**LANTNAVFACENGCOM Comments
to
ESE Preliminary Draft Reports**

**RI (Hadnot Point)
and
SA (Sites 6, 48, and 69)**

**Reviewed by Laurie Boucher
7/26/91**

Doc. No. : 0L3T-00688-3.13-07/26/91

FIGURE 1-4
SITE 69,
RIFLE RANGE CHEMICAL DUMP

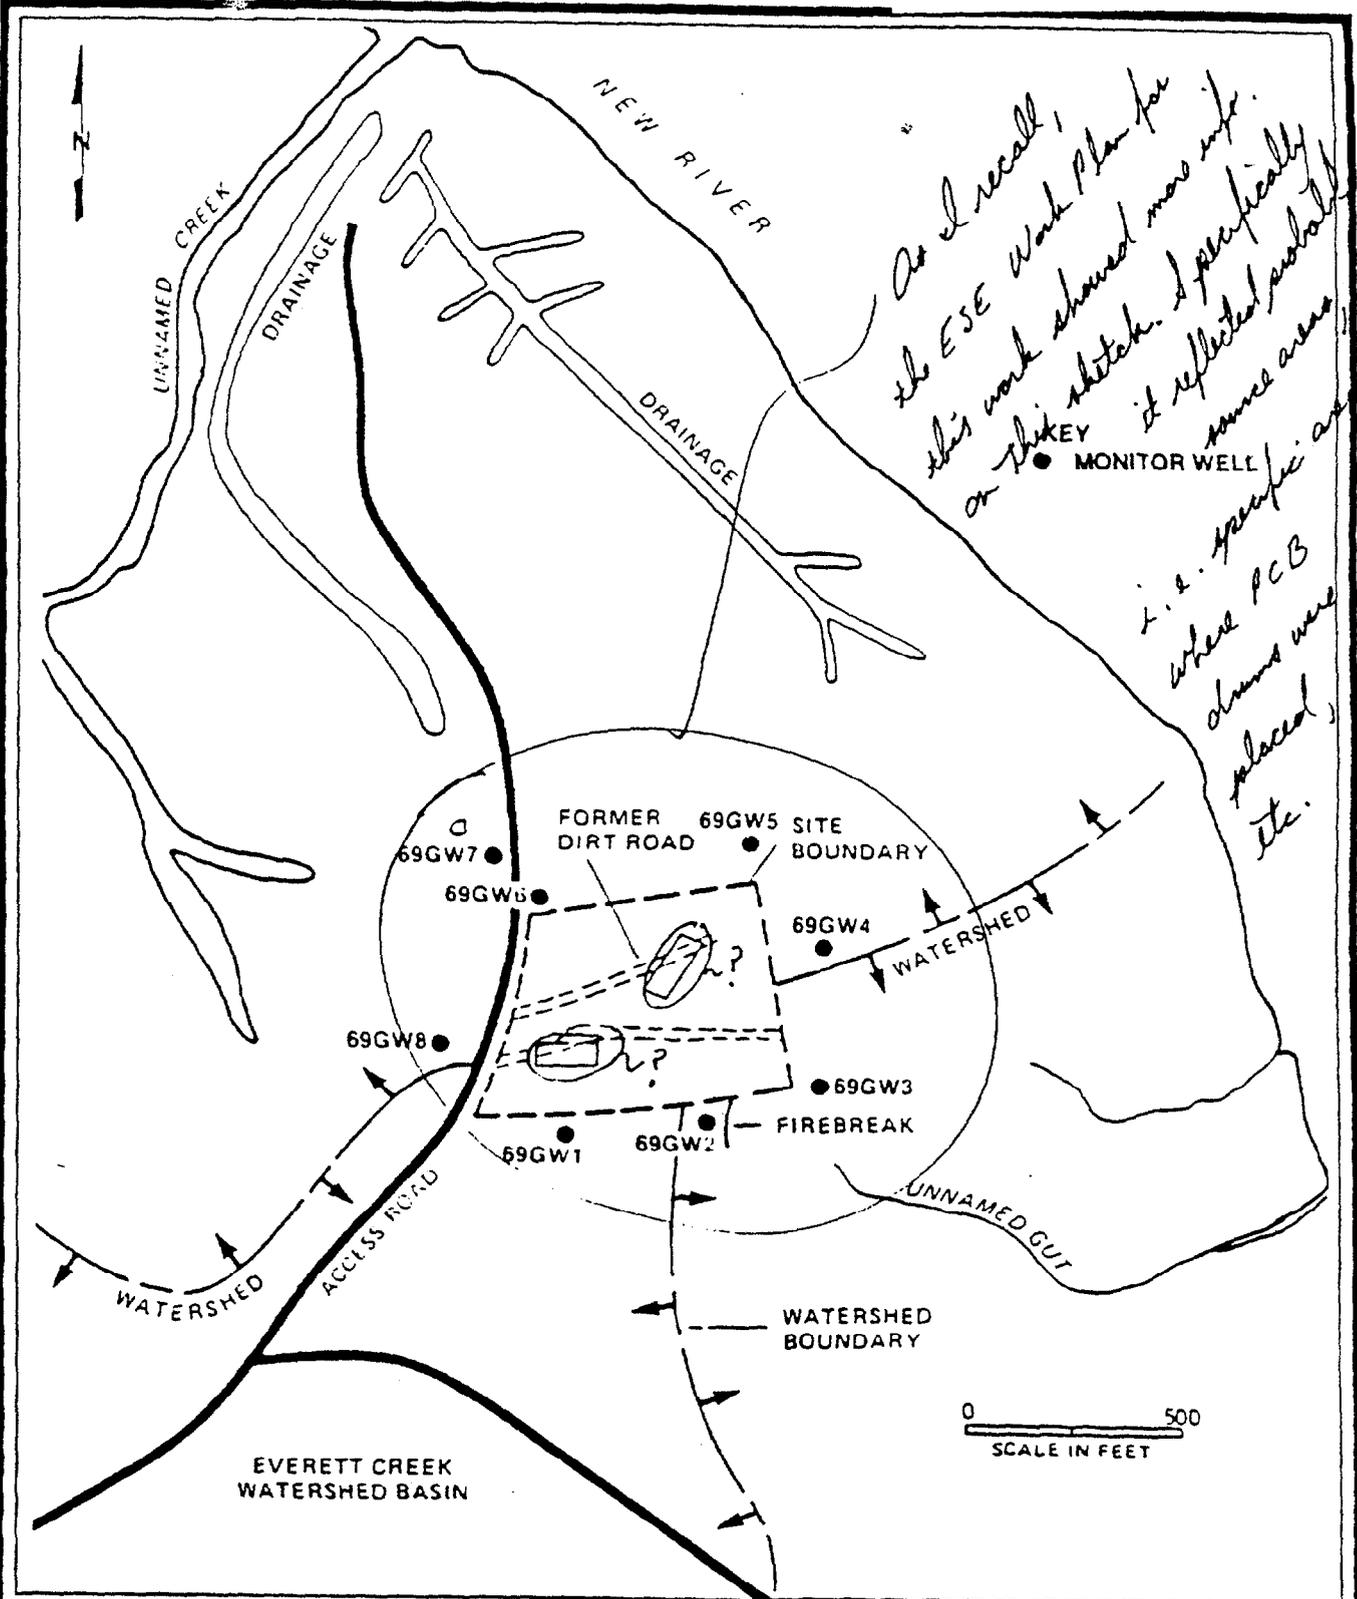
check spelling
